UNITED STATES  
DEPARTMENT OF THE INTERIOR  
BUREAU OF LAND MANAGEMENT  
**APPLICATION FOR PERMIT TO DRILL OR REENTER**

**EOG RESOURCES, INC.**  
**DEEP ELEM 4 FED COM #766H**

## PECOS DISTRICT DRILLING CONDITIONS OF APPROVAL

OPERATOR'S NAME:	EOG RESOURCES INCORPORATED
WELL NAME & NO.:	DEEP ELEM 4 FED COM 766H
SURFACE HOLE FOOTAGE:	1488'/S & 2003'/W
BOTTOM HOLE FOOTAGE:	230'/S & 1310'/W Sec 16 T26S R31E
LOCATION:	Section 4, T.26 S., R.31 E., NMP
COUNTY:	Eddy County, New Mexico

Proposed Wellbore  
Design B

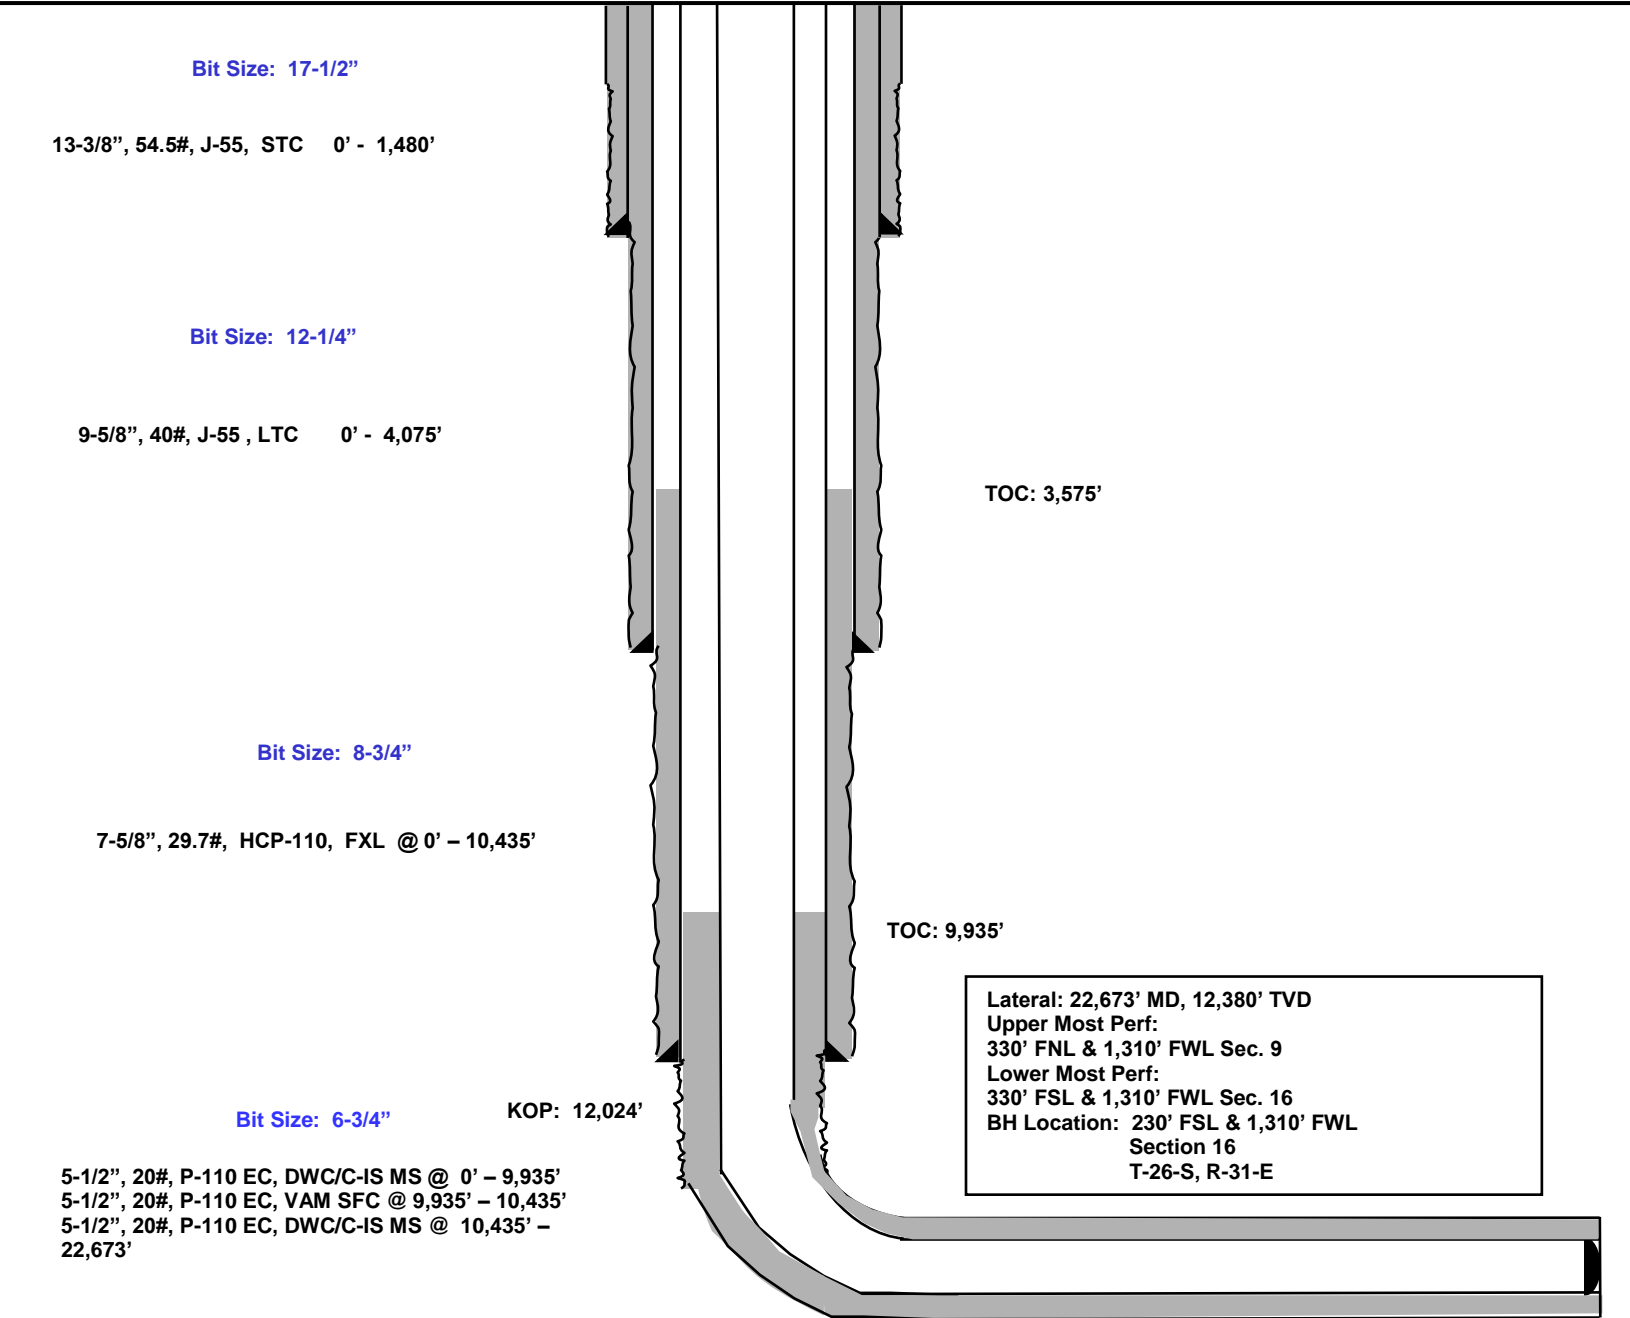
**Operator is only approved for Design A. Design B is not to be utilized. If Design B is needed or any other change, please submit a NOI sundry to make the changes.**
